Comments on ISOM First Draft, 30 June 2013

Prepared by Adrian Uppill, Orienteering Australia

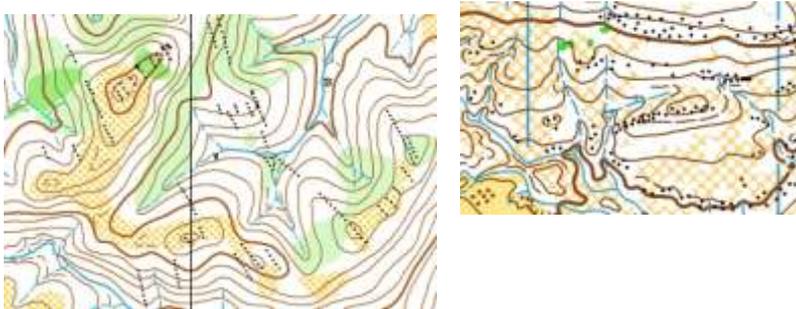
As a first step the reference to Control Descriptions should be deleted. Although useful it does not form part of a mapping specification. If the control descriptions are to be imbedded into the mapping specifications it will then become virtually impossible to make changes to control descriptions. In this regard Orienteering Australia in June 2011 made a suggestion to the Chair IOF Rules Commission for further unification of the symbols used for control descriptions and mapping ie

1.10 Knoll		to	
2.4 Boulder		to	
2.5 Boulder field		to	
2.6 Boulder cluster		to

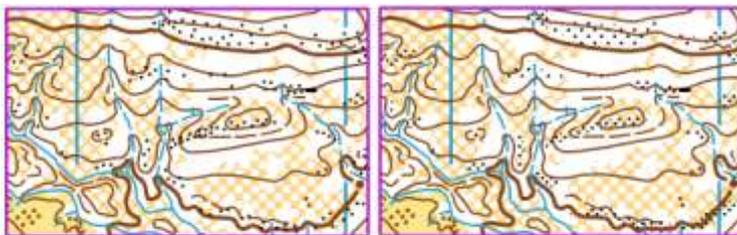
The draft proposes to abandon some symbols that are particularly appropriate to Australian terrains by restricting stony ground, boulder field and broken ground to fixed density, area symbols. The current symbols work well for the Australian terrain. The dots or shape symbols should be individually placed. There are terrains in Australia which have for example lines of rocky or stony outcropping and it is here that the single dot best describes the terrain.

In particular the draft proposes to ban the drawing of a single row of dots. Although the freehand drawing of a single row of dots may appear to cause confusion with 416 Distinctive vegetation boundary (uses the larger dot size of 0.22 at a regular interval), this has not caused a problem on Australian maps.

The map examples below show distinctive narrow bands of rock outcropping, to outcropping at varying density and variable width, and to isolated outcropping.

The current single dot (stony ground and broken ground) and single shape (boulder field) symbols must therefore be retained.
